Product Change Notification

Change Notification #: 115839 - 00
Change Title: Intel® Server System R2208GZ4GC,
PCN 115839-00, Product Design, Label,
Update Regulatory and Safety Labels and
change air duct lock feature
Date of Publication: October 9, 2017

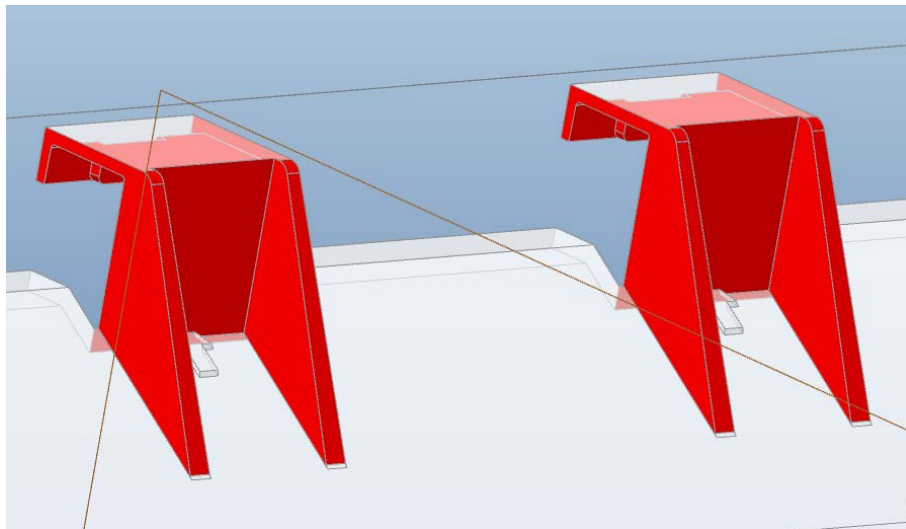
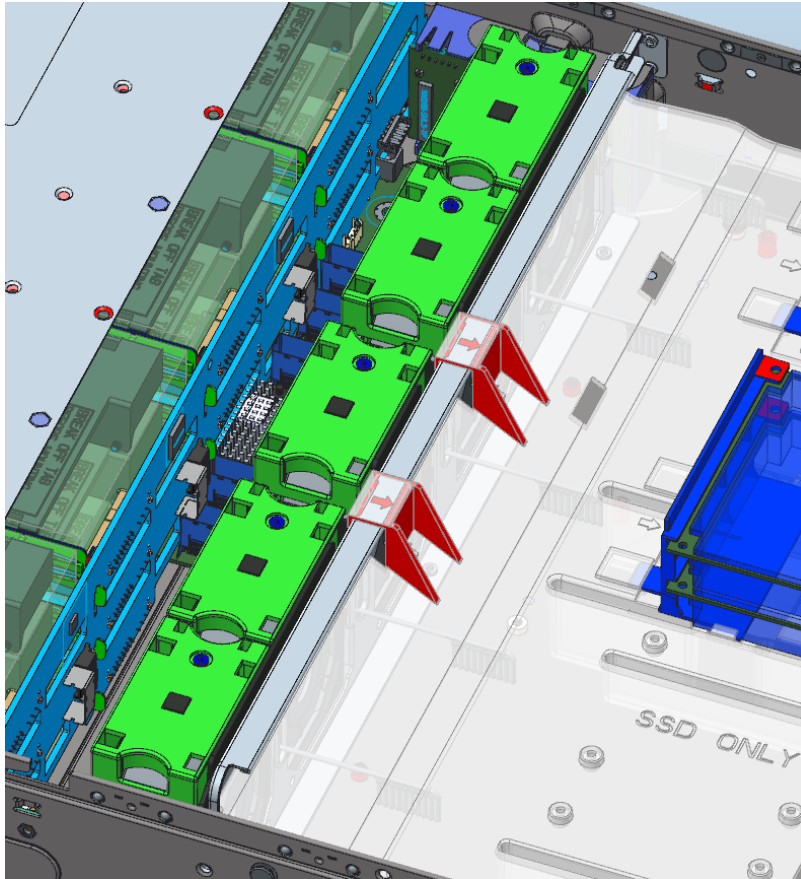
3. Update Motherboard to PBA G11481-356 with the below changes:
 - a. Update the PBA label using a small label with RCM logo to cover C-Tick logo. Please see Figure-1 and Figure-2 below for details.
